Service Bulletin

Bulletin No.: 18-NA-020

Subject: Malfunction Indicator Lamp Illuminated with DTC P0300 and/or P0299/P2227 Set

This Bulletin replaces PIP5511A. Please discard PIP5511A.

4597334

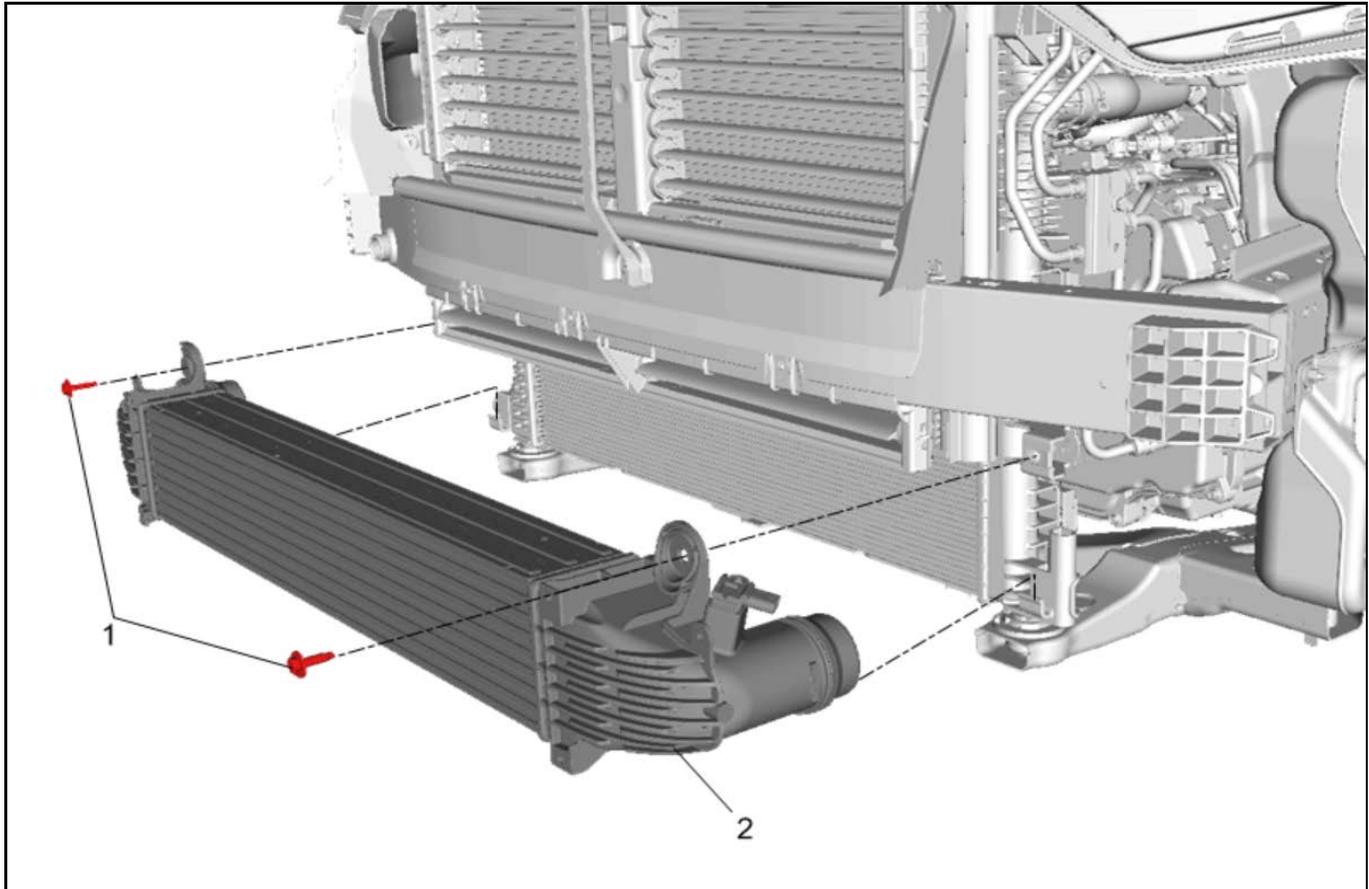
1. Perform a smoke leak test of the charge air cooler.

- If a leak is determined, replace the charge air cooler with the newly designed part. Refer to *Charge Air Cooler Replacement* in SI.
- If there is NO leak, but a P0300, P0299 and/or P2227 are present, **AND the vehicle was built ON or BEFORE March 1, 2018**, then replace the charge air cooler with the newly designed part. Refer to *Charge Air Cooler Replacement* in SI.
- If there is NO leak, but a P0300, P0299 and/or P2227 are present, **AND the vehicle was built AFTER March 1, 2018**, refer to SI for further diagnosis.

5274387

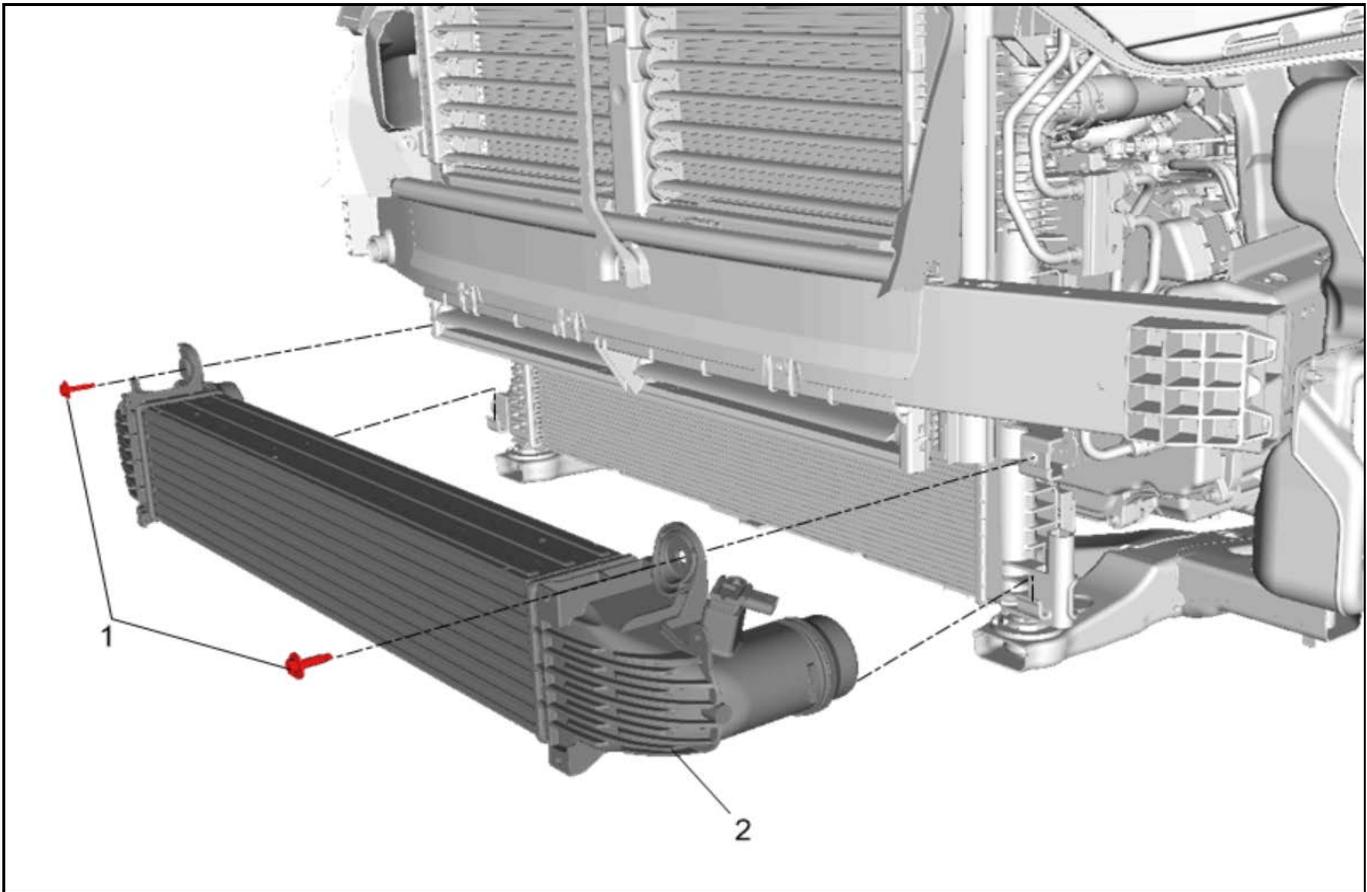
4. Fold the ends on the outer panel body deadener with the paper side facing the cooler and install zip ties around the cooler to retain the deadener in the 3 location.

Important: There should be at least 1/2" (13mm) fold on the top and bottom of the deadener.
